**Request for Technical Specifications Change, Transition to General Electric Fuel**

**Proposed Changes to Technical Specifications  
for Dresden Nuclear Power Station, Units 2 and 3**

**Attachment A**  
**Proposed Changes to Technical Specifications**  
**for Dresden Nuclear Power Station, Units 2 and 3**  
**DESCRIPTION AND SAFETY ANALYSIS**  
**FOR PROPOSED CHANGES**

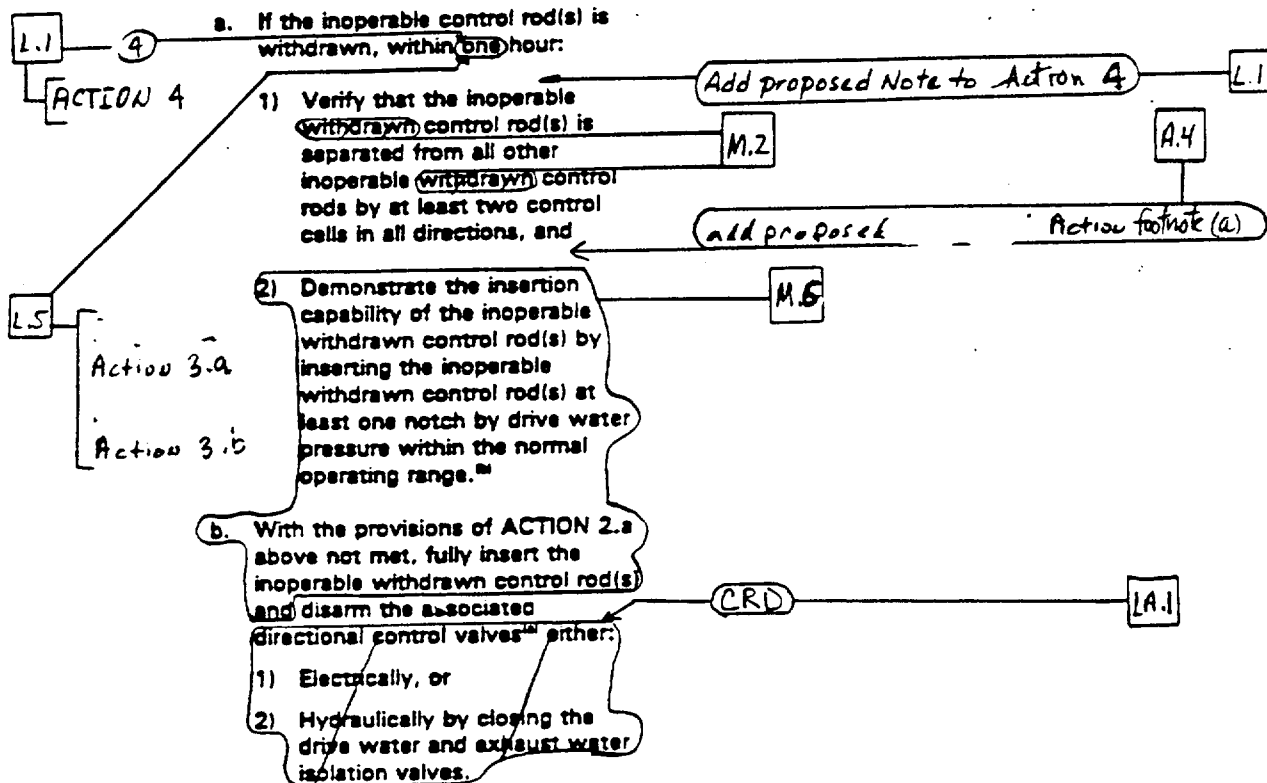
Action 1.c ~~c. Comply with Surveillance Requirement 4.3.A.2 within 24 hours or be in HOT~~ (72) (not 70) L.4

ACTION 5 ~~SHUTDOWN within the next 12 hours.~~

ACTION 3 2. With one or more control rods scrammable but inoperable for causes other than addressed in ACTION 3.3.C.1 above:

b. The inoperable control rod may then be withdrawn to a position no further withdrawn than its position when found to be inoperable. M.6
